| TYPE | YEAR | PROJECT NO. | SHEET NO. |
|---|---|---|---|
| R.O.W. | 2015 | HSIP-106(33) | 24 |
| CONST. | 2017 | HSIP-106(33) | 34 |

S.R. 106 WILLIAMSON CO.

BEGIN STA. 116+50.00
END STA. 117+50.00

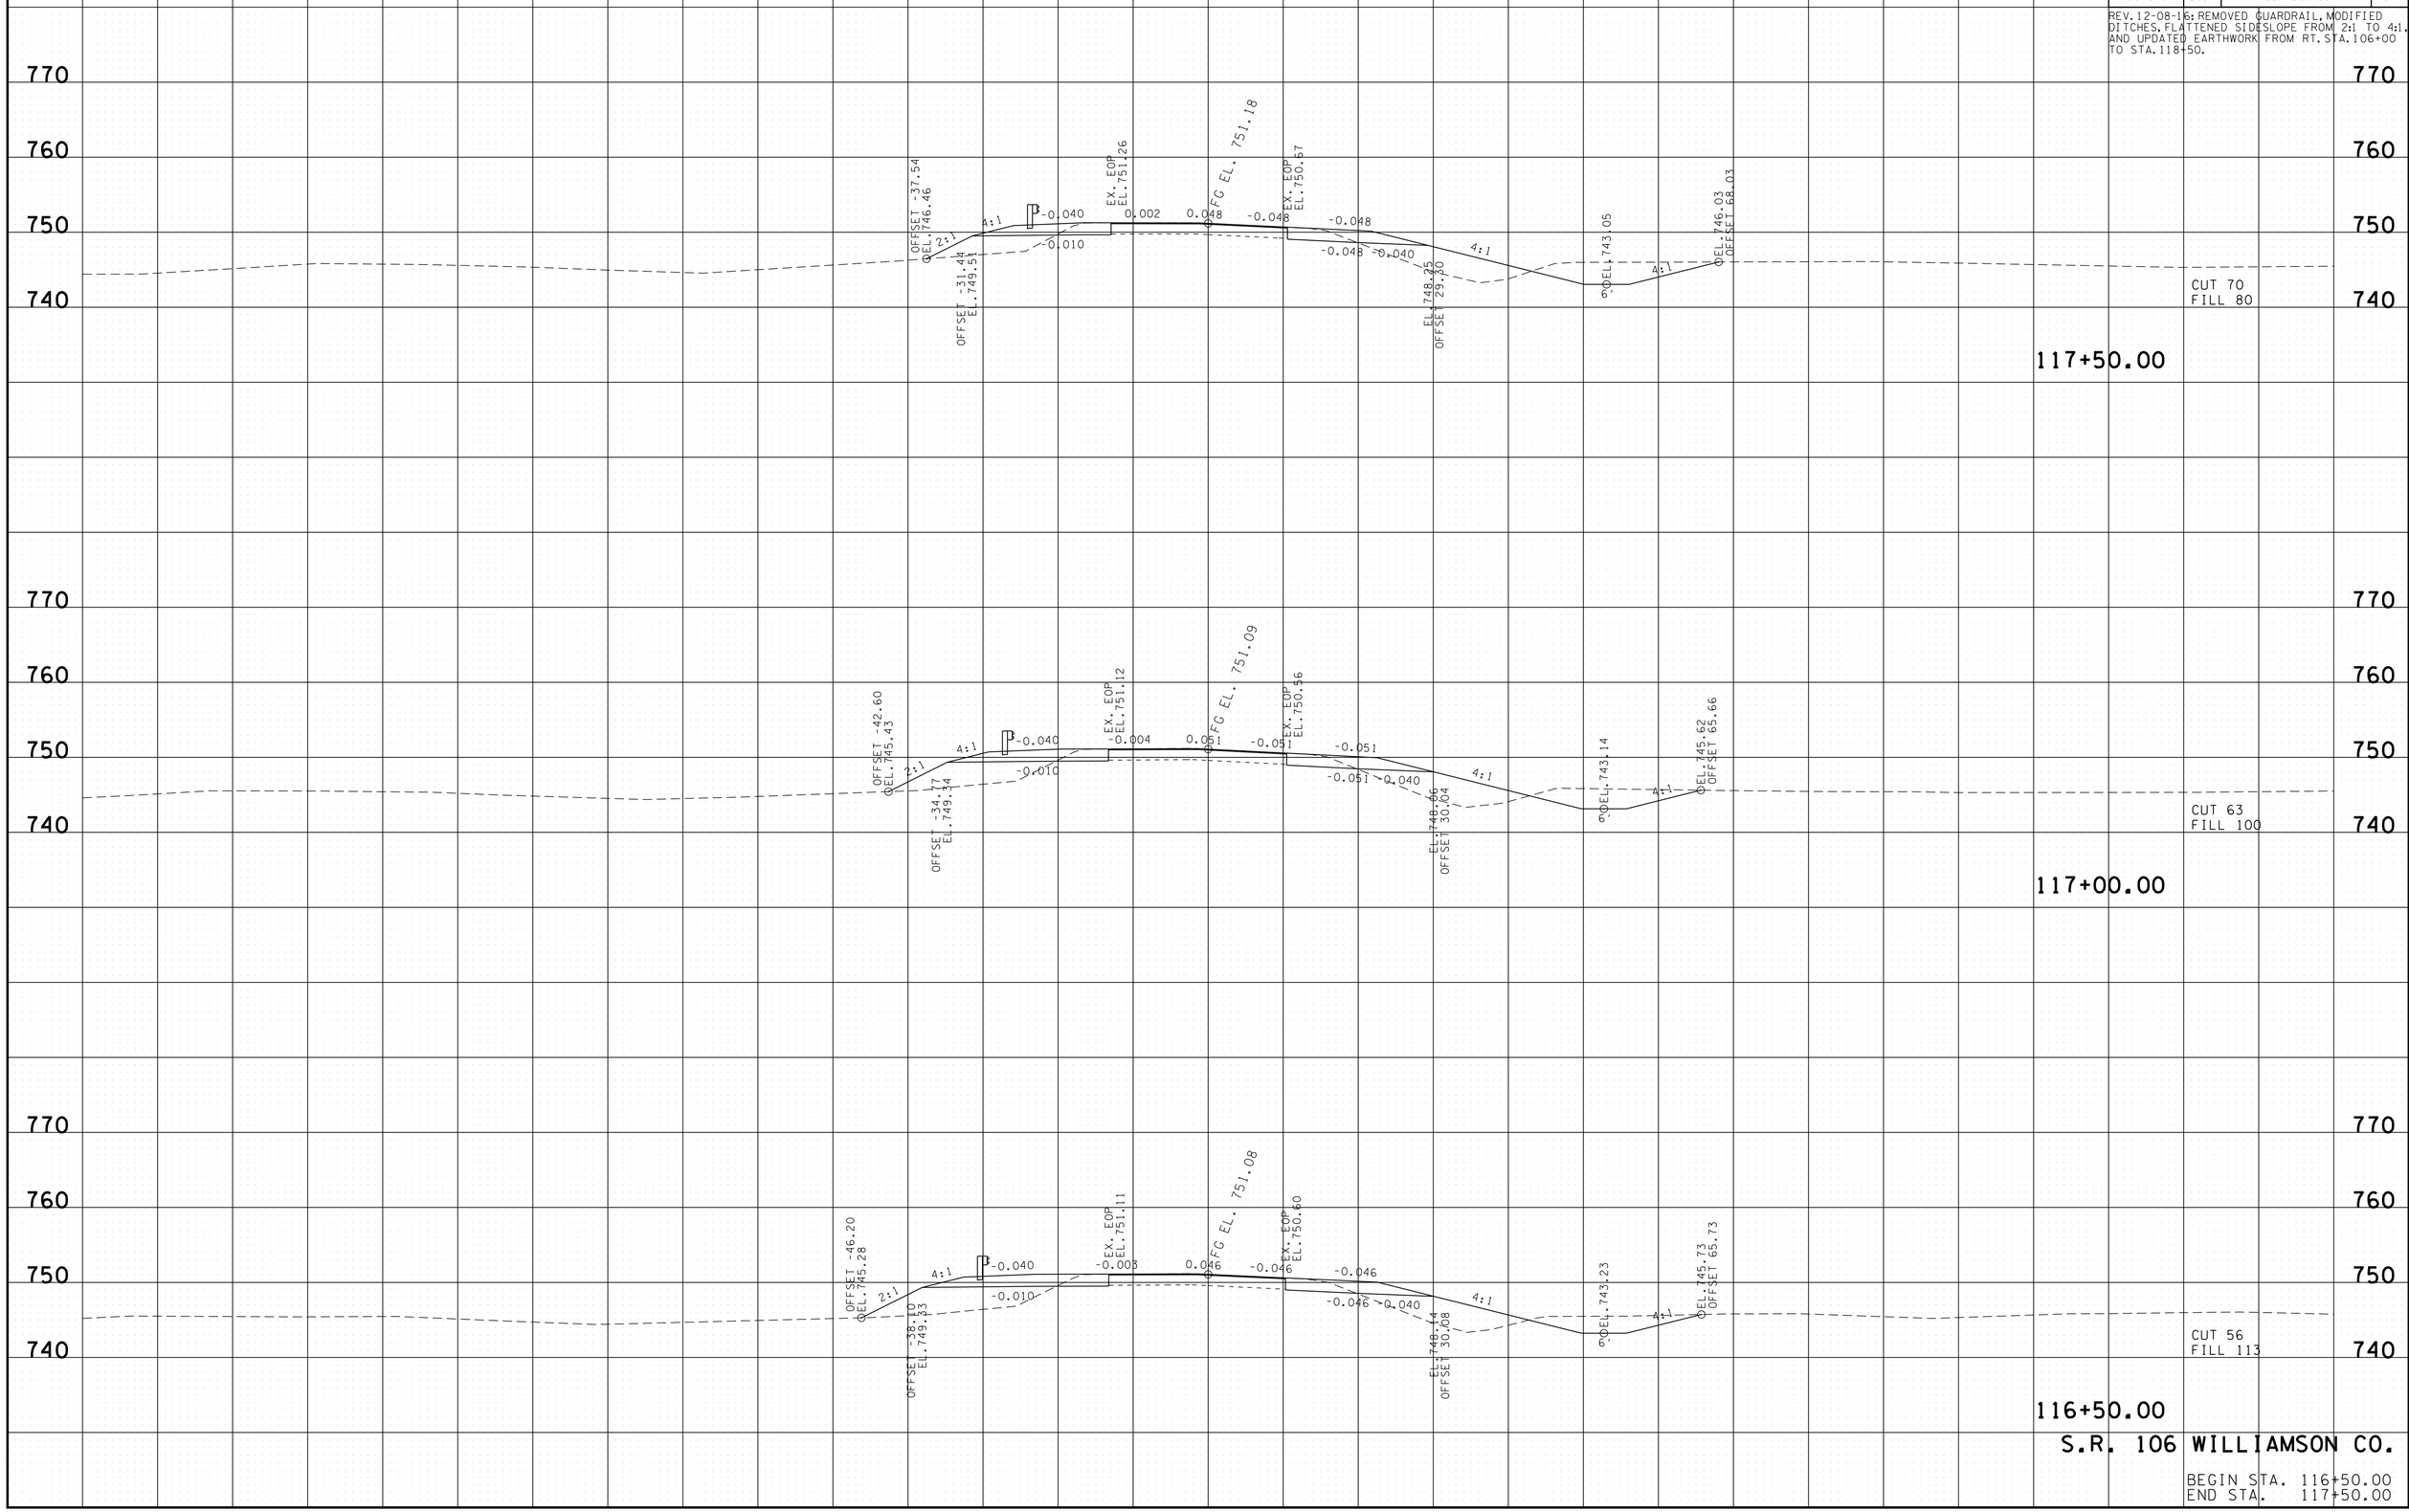
REV. 12-08-16: REMOVED GUARDRAIL, MODIFIED DITCHES, FLATTENED SIDESLOPE FROM 2:1 TO 4:1, AND UPDATED EARTHWORK FROM RT. STA. 106+00 TO STA. 118+50.
